# Access Compliance Report

## Public Rights-of-Way

### (Pedestrian Signals)

Intersection ID: N/A	Main Street:	Cross Street: N/A	Location: N/A
ADA ID: 97FD6477FD1A	Signal Type: One Push Button-Non APS	Overall Compliance: No	Severity Score: BTN 1: N/A BTN 2: N/A No BTN: N/A
Codes/Mitigation Info/Possible Solution		Field Measurements/Component Compliance

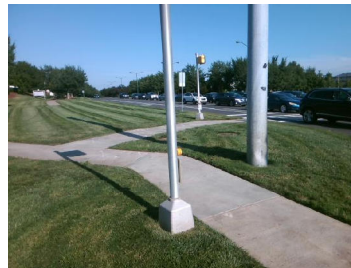
PROW/ADA: TMUTCD 4e.08, R404.2, R404.3, R406.2, R404.7.3

Yes	B 1 Clear Xing Direction?	ClearlyMarked	N/A	B 2 Clear Xing Direction?	N/A
	B 1 Crossing Direction	To E		B 2 Crossing Direction	N/A
Yes	B 1 DistanceTo XWalk (in)	0.0	N/A	B 2 DistanceTo XWalk (in)	N/A
No	B 1 DistanceTo Curb (in)	156.0	N/A	B 2 DistanceTo Curb (in)	N/A
Yes	B 1 Diameter (in)	2.0	N/A	B 2 Diameter (in)	N/A

Possible Solutions: Replace Signal Push Button With APS Button on New Post. Remove & Relocate Sign.
